SCHOLZ / ORCUTT:

Markup Summary

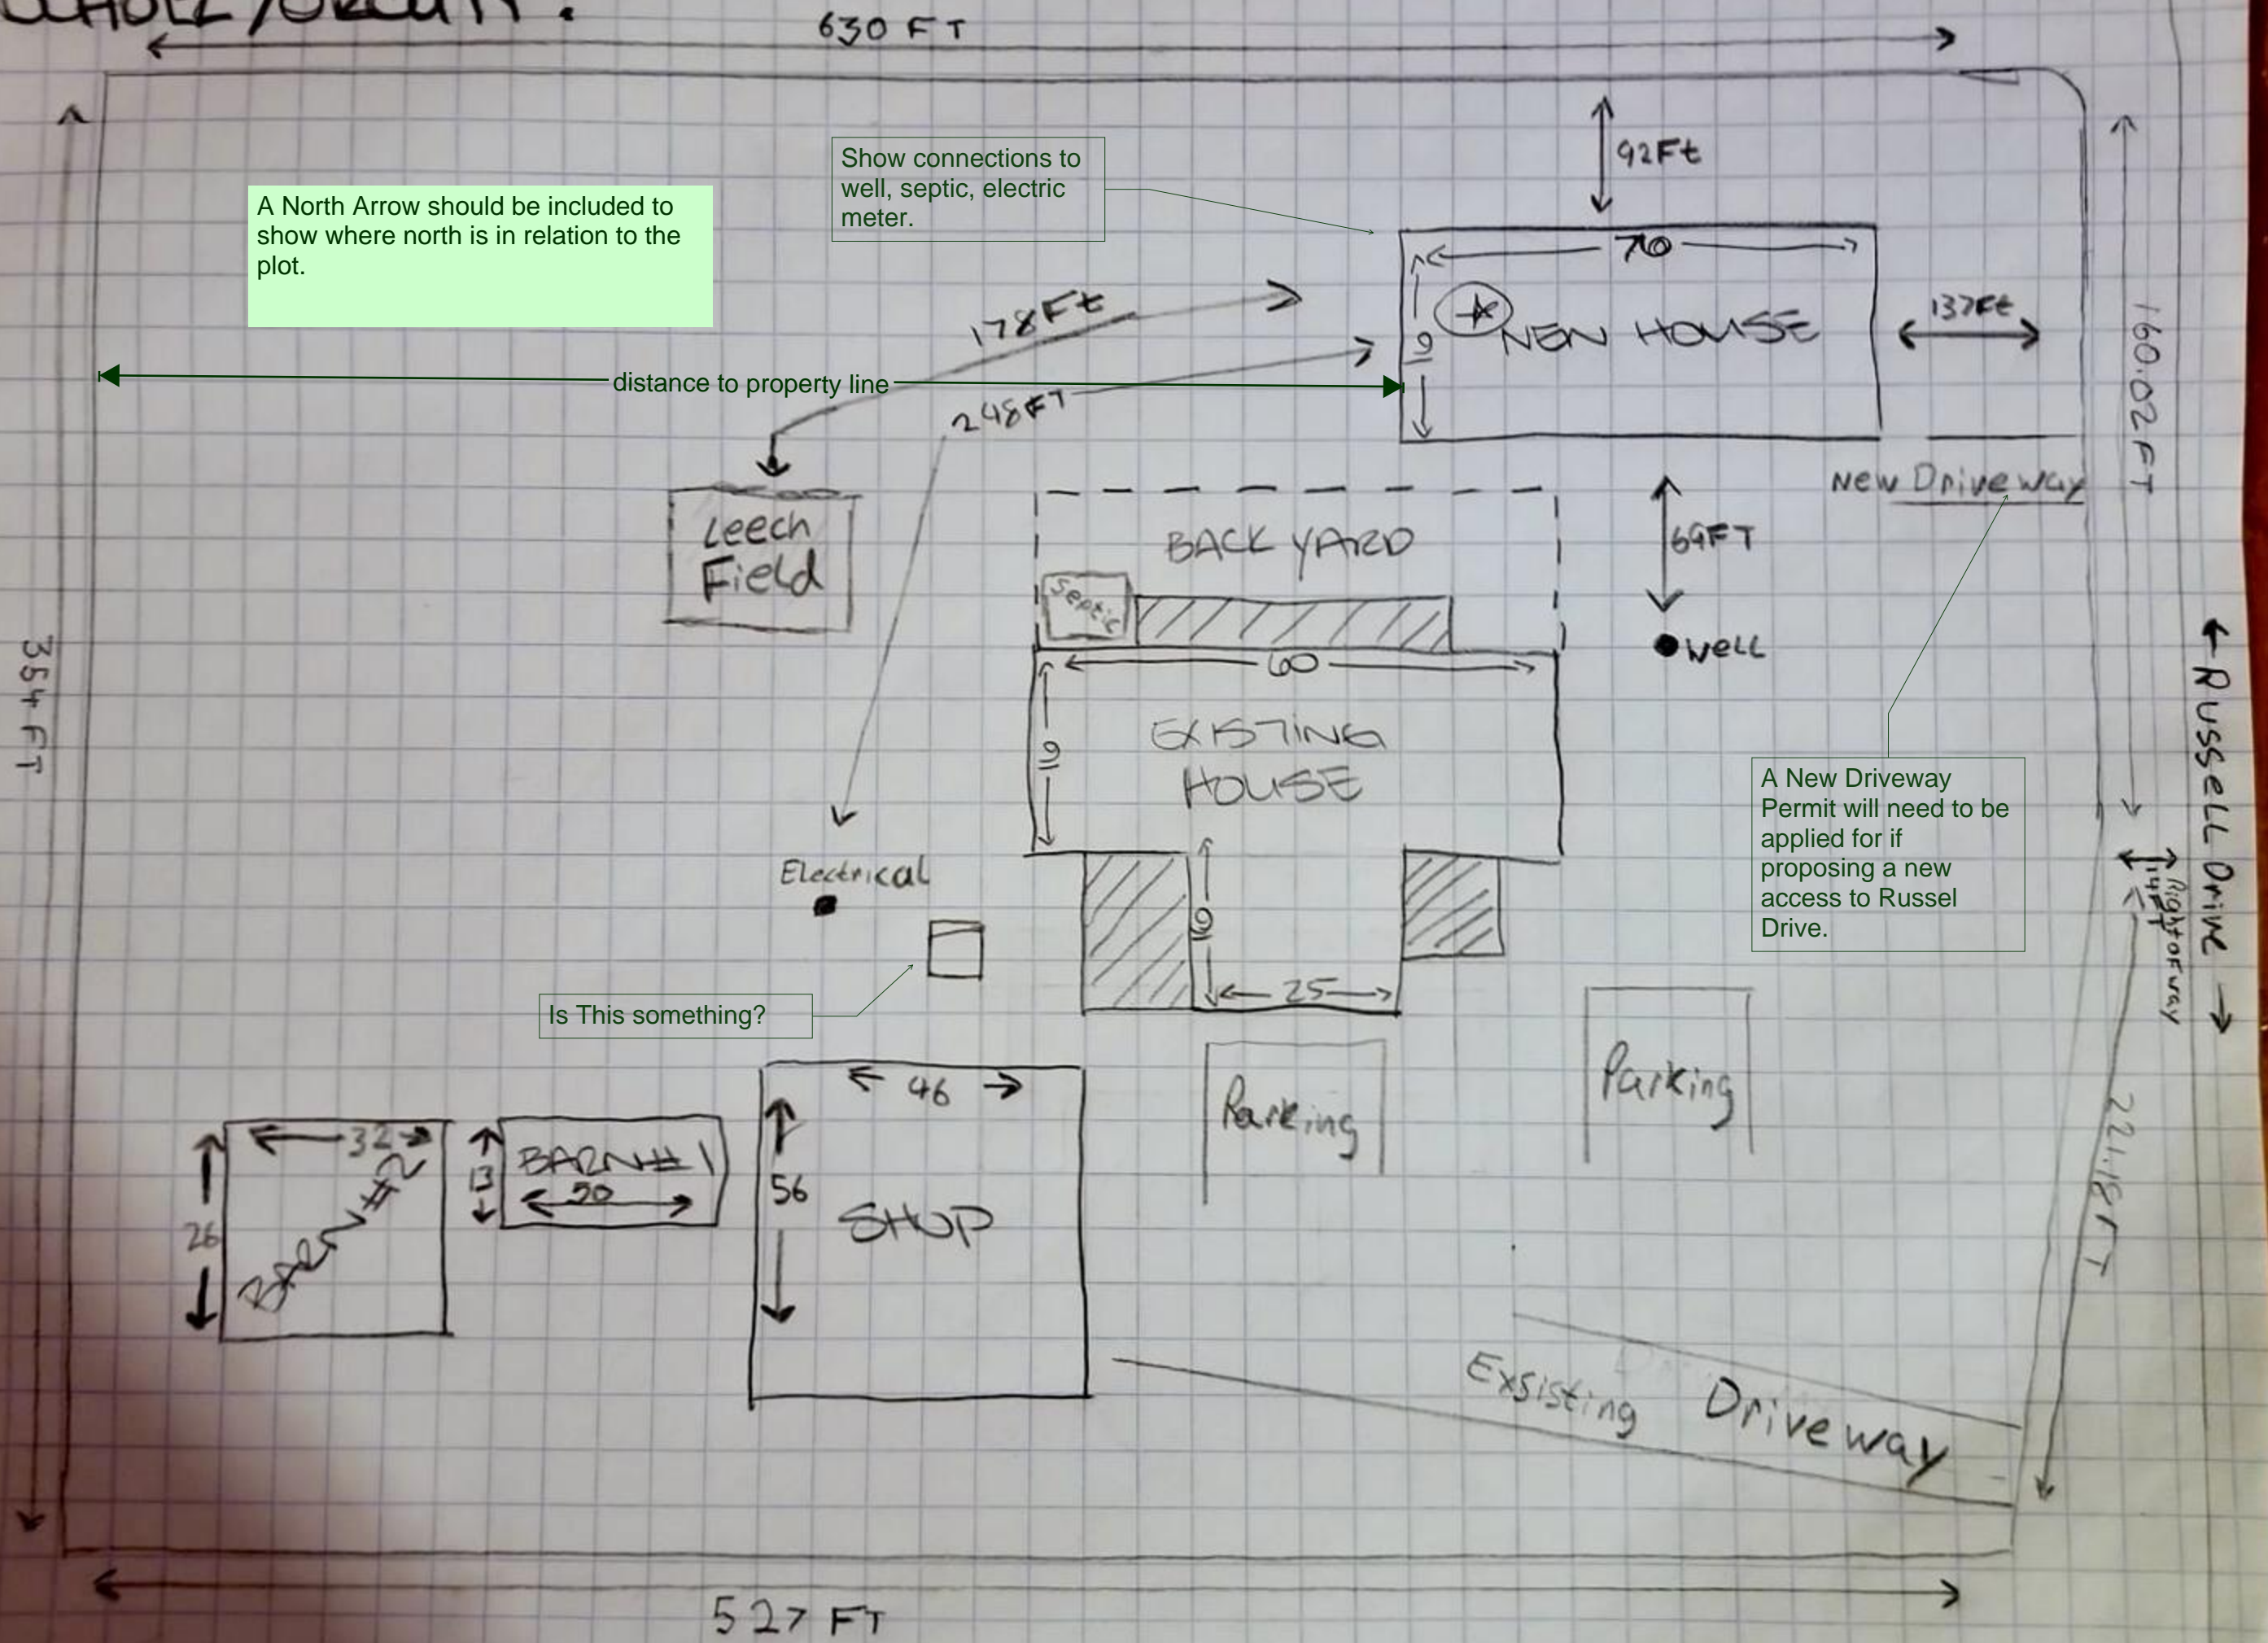
A North Arrow should be included to show where north is in relation to the plot.

Show connections to well, septic, electric meter.

Is This something?

A New Driveway Permit will need to be applied for if proposing a new access to Russel Drive.

distance to property line
